St Mary's Rainbow Preschool

Updated Traffic Impact Assessment

28 March 2025

Council officers provided comments in relation the assessment the proposal as part of a Request for Information (Ref No: D/2024/0374, dated 7 March 2025). Matters relevant to be addressed in a revised Traffic Impact Assessment (this document) are summarised in Table 1 along with a response and reference location.

Figure 4: Turning Movement Count Peak Hour Survey Results - Factored Up by 20%

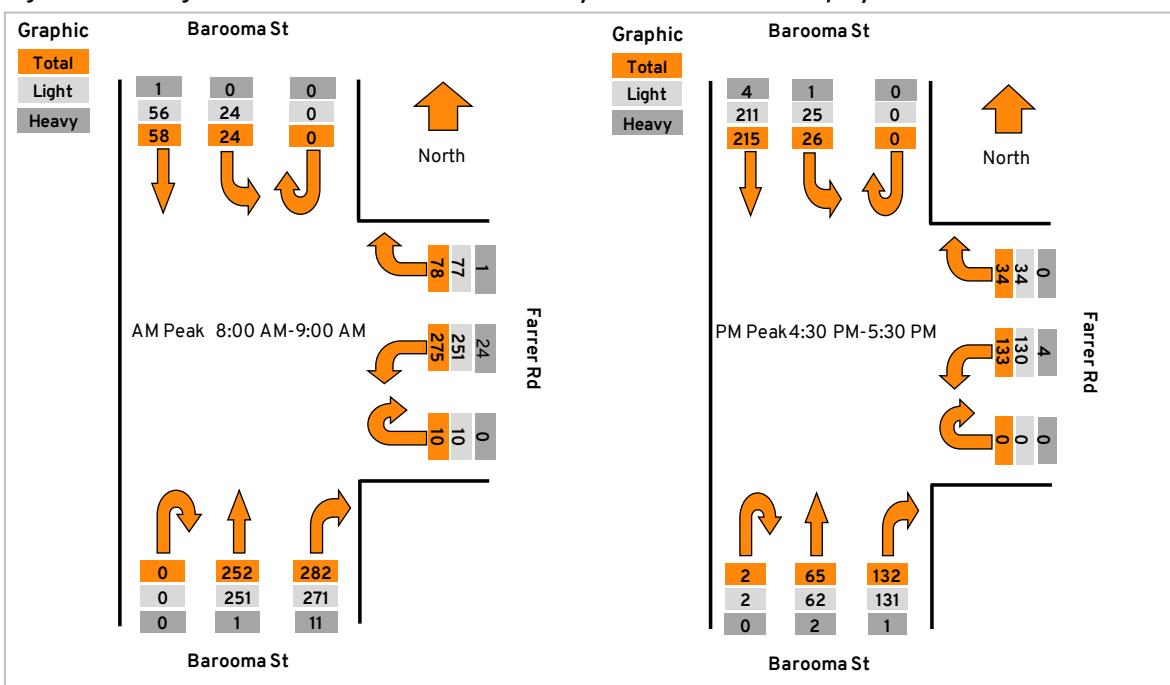
Matter	Wagga Wagga Comment	Response	Reference Location
Traffic Data	<p><i>The traffic data referenced under part 2.3.2 of the report was undertaken on Thursday 7 December. At this time of the year university has finished, year 12 students are finished and as the last week of school the trip numbers recorded are not considered representative of a normal day. The figures are therefore, as expected, much lower than the traffic volumes that were collected during term time in May.</i></p> <p><i>Update the traffic report to reflect existing movements at the Farrer Road/Boorooma Street roundabout and determine where traffic is coming from and going to during peak drop-off periods that will correlate with the peak drop off period of the proposed preschool.</i></p>	<p>A comparison of the data recorded in May 2023 (seven day counts on Farrer Road) and those undertaken in December 2023 at the intersection of Farrer Road Boorooma Street has been undertaken. This showed that the data recorded at the intersection was generally higher than that recorded in May.</p> <p>Nevertheless, to ensure that the baseline traffic data at the intersection reflects road conditions during the school and university year, the traffic intersection survey has been factored by 20%.</p> <p>It should be noted that revised traffic counts are not able to be undertaken and processed within the RFI response timeframe.</p>	Section 2.3.3, Table 3 and Figure 4

As shown in Table 3, the results recorded at the intersection during the peak hours were generally higher than that recorded on Farrer Road in May 2023.

Nevertheless, to ensure that the intersection traffic surveys are reflective of typical conditions at the intersection to reflect the operation of the University and Anglican College, the results of the intersection survey have been factored up by 20% as shown in Figure 4.

The factored-up values shown in Figure 4 have been used for the purposes of the traffic assessment as outlined in Section 4 below.

Figure 7: Estimated Traffic Volumes Generated by Proposed Development - Left Turn Egress Only

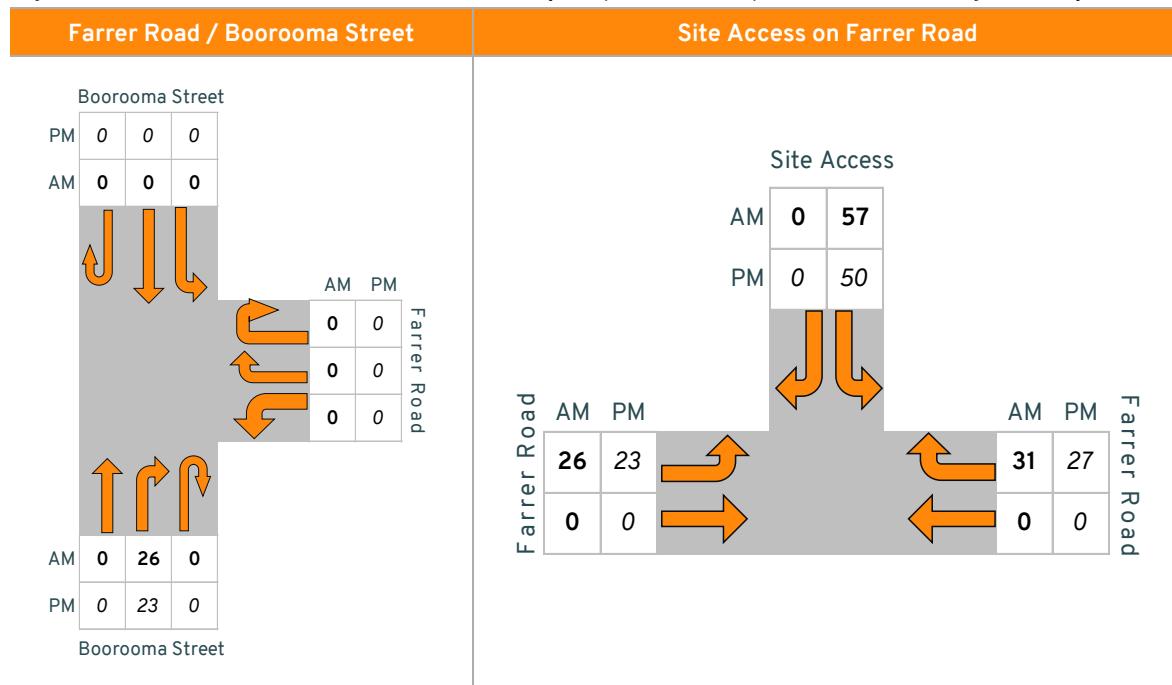
Matter	Wagga Wagga Comment	Response	Reference Location
Right turn egress from proposal	<p><i>It is anticipated that the majority of parents leaving the centre will want to turn right either back towards the university or onto Boorooma Street and into the CBD. The right hand turn out of the centre onto Farrer Road is of concern and the use of an internal road within the university campus remains the preferred outcome for access in and out of the centre.</i></p> <p><i>It is unclear if the existing traffic assessment of vehicles exiting the site has fully considered the proposed right turn movements during peak hour when vehicle numbers travelling east are high and vehicles travelling west may also be waiting to turn into the site. The commentary under section 4.2.1 is that there is likely to be minimal queuing within the site for vehicles waiting to exit onto Farrer Road during both the morning and evening peak hours. Provide greater clarity to justify this statement and determine whether right turns out of the site can be or need to be restricted. In addition, confirm that the school zone restrictions in this location have been factored into the analysis.</i></p>	<p>Additional commentary has been added in relation to the anticipated performance of right turns from the proposal which outline the expected delays and queuing impacts. The average queue at the site egress is expected to be less than one vehicle.</p> <p>A scenario has been modelled that would restrict egress movements from the proposal to left turns only. This shows similar intersection performance as full access to and from the site, noting the delays for motorists departing the site would be reduced.</p> <p>An indicative plan has been prepared on how a left turn only arrangement could operate.</p> <p>Ultimately, the assessment shows that the site access would operate in a satisfactory manner with or without right turn egress.</p> <p>The school zone speed limits have been applied in the SIDRA analysis.</p> <p>It is recommended that the school zone restrictions of Farrer Road be modified to suit the proposed access and shifted west to reduce road safety risks, subject to approvals and consideration by Council and TfNSW.</p>	<p>Section 4.2.2, (below Table 8) for performance of right turn egress movements.</p> <p>Section 4.1.2, 4.2 for assessment and commentary on left turn only egress.</p> <p>Section 6.3 outlines an indicative plan on how left turn only arrangements could be implemented.</p> <p>Section 6.4.1 for comments on the school zone.</p>

In response to feedback received from Council in March 2025, an alternative scenario has been developed where motorists must depart the site via left turns only, which would be via appropriate signage and on-road treatments as described in Section 6.3. The model assumptions and distributions are otherwise identical to that outlined above. The resulting traffic volumes generated by the site are outlined in for the site access on Farrer Road and the Farrer Road / Boorooma Street roundabout where all egress from the site is via left turns only.

As shown in the figure above, were egress limited to left turns only, all traffic departing the site in the peaks hours would be distributed to the east and would not generate additional traffic through the Farrer Road / Boorooma Street roundabout.
